RIVERSIDE CLINIC

TENANT IMPROVEMENT

FIRST FLOOR PLAN

A-101

1 FIRST FLOOR PLAN

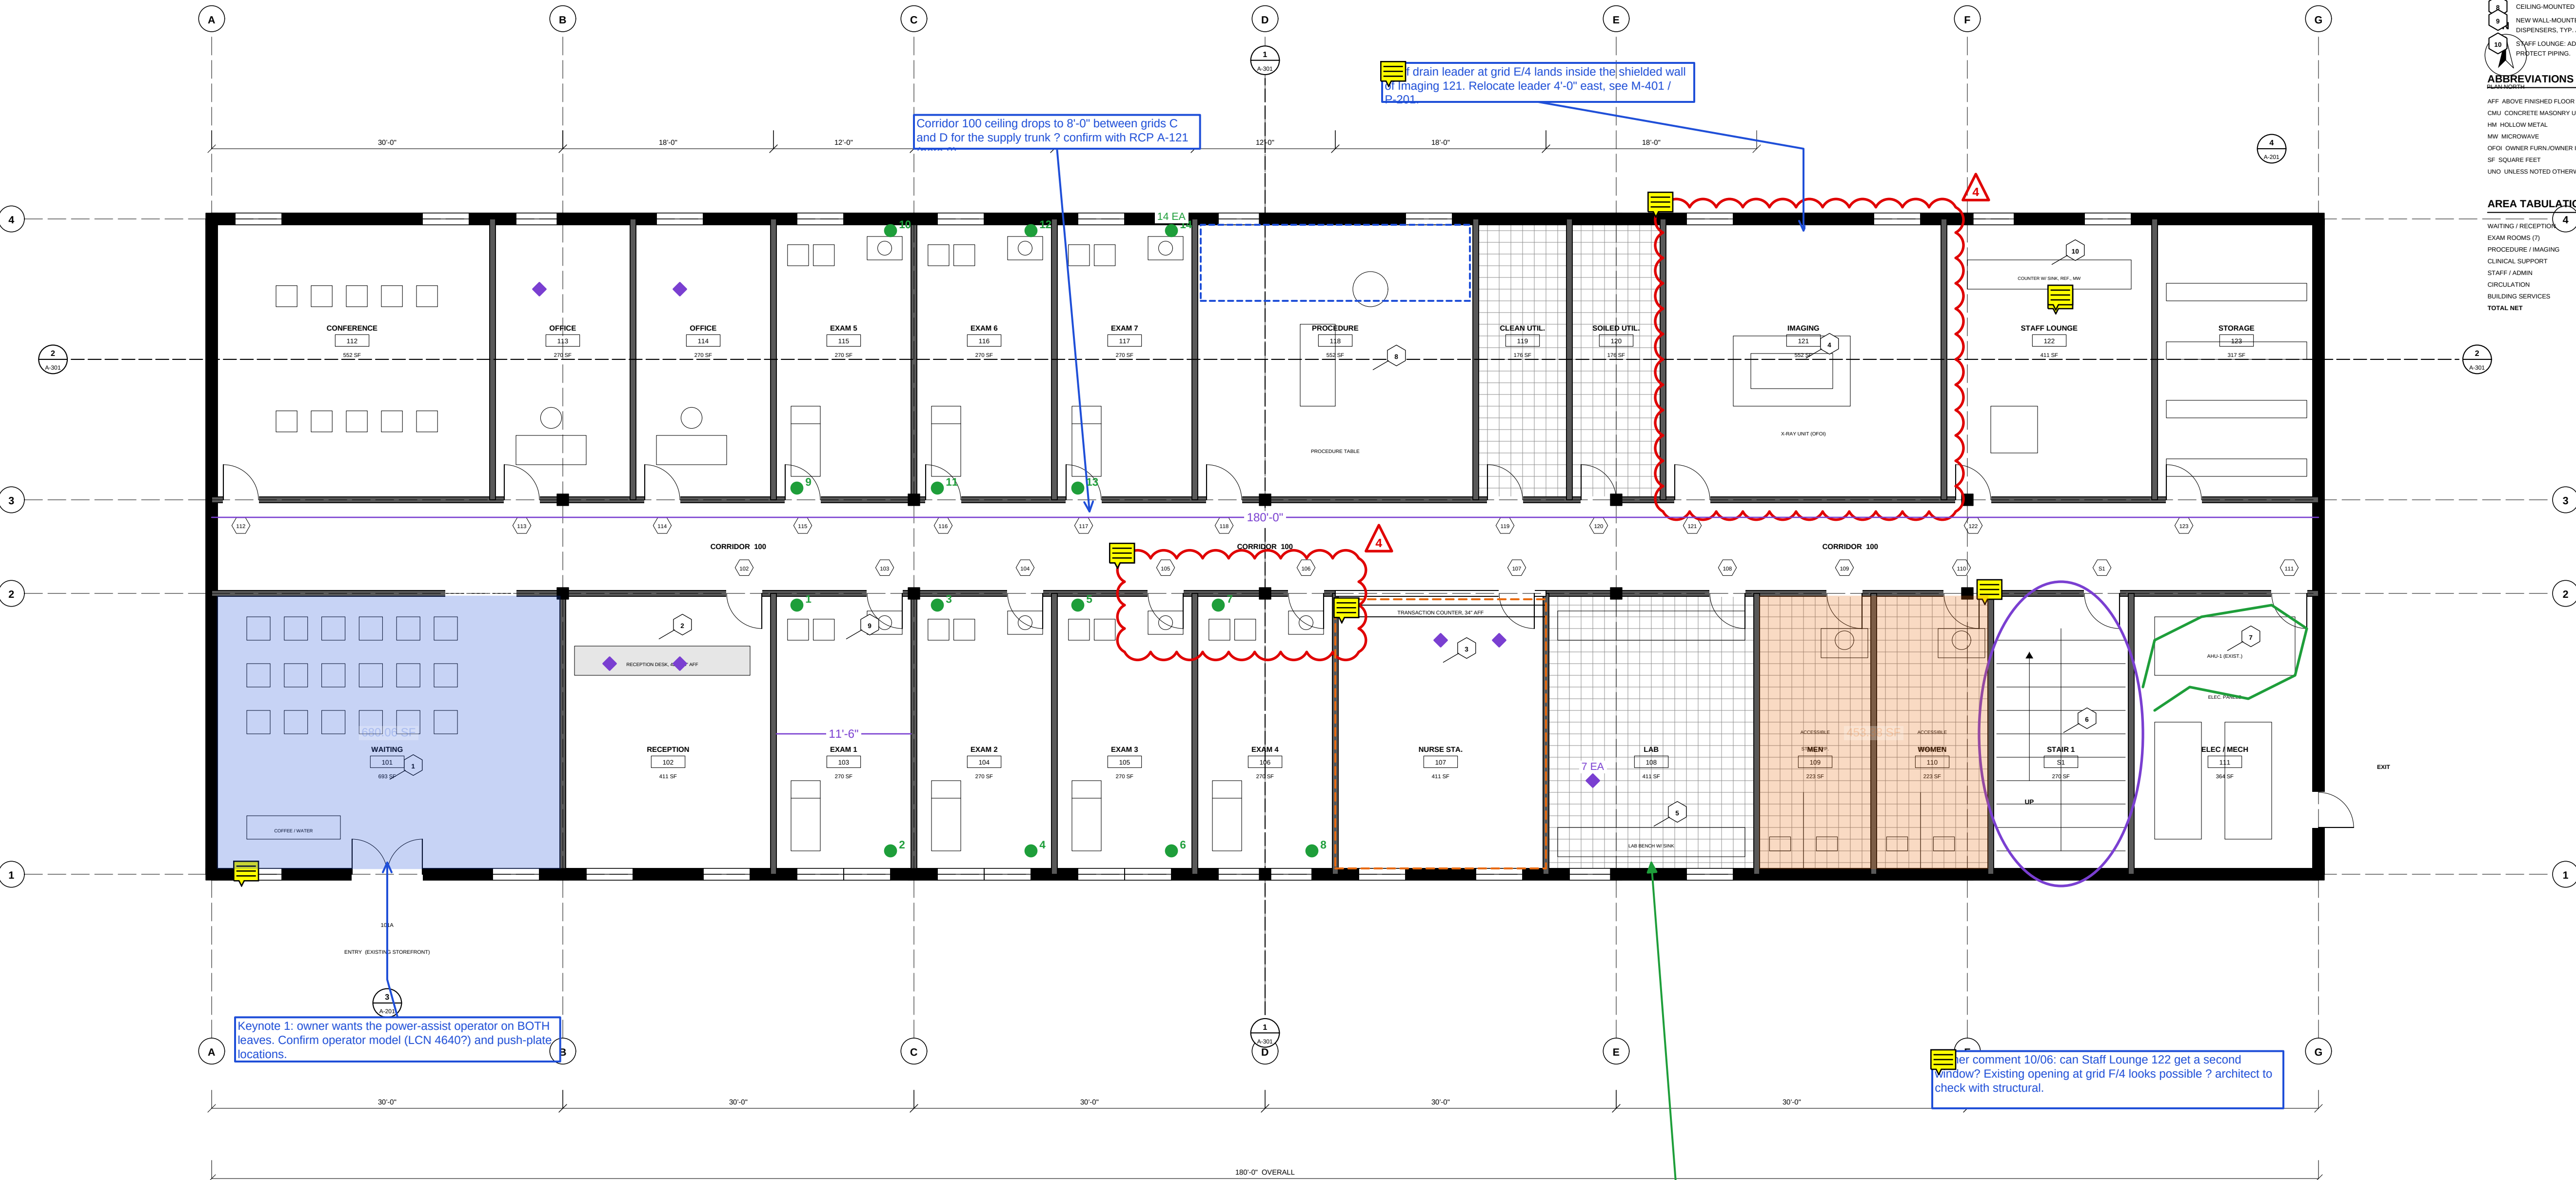
Author	Count	Comments
J. Alvarez	9	ASI 04: doors 105 and 106 to swing...
M. Chen	3	Keynote 1: owner wants the power...
R. Okafor	5	RFI 027 ? Existing slab at Lab 108 l...
S. Patel	26	Roof drain leader at grid E/4 lands l...
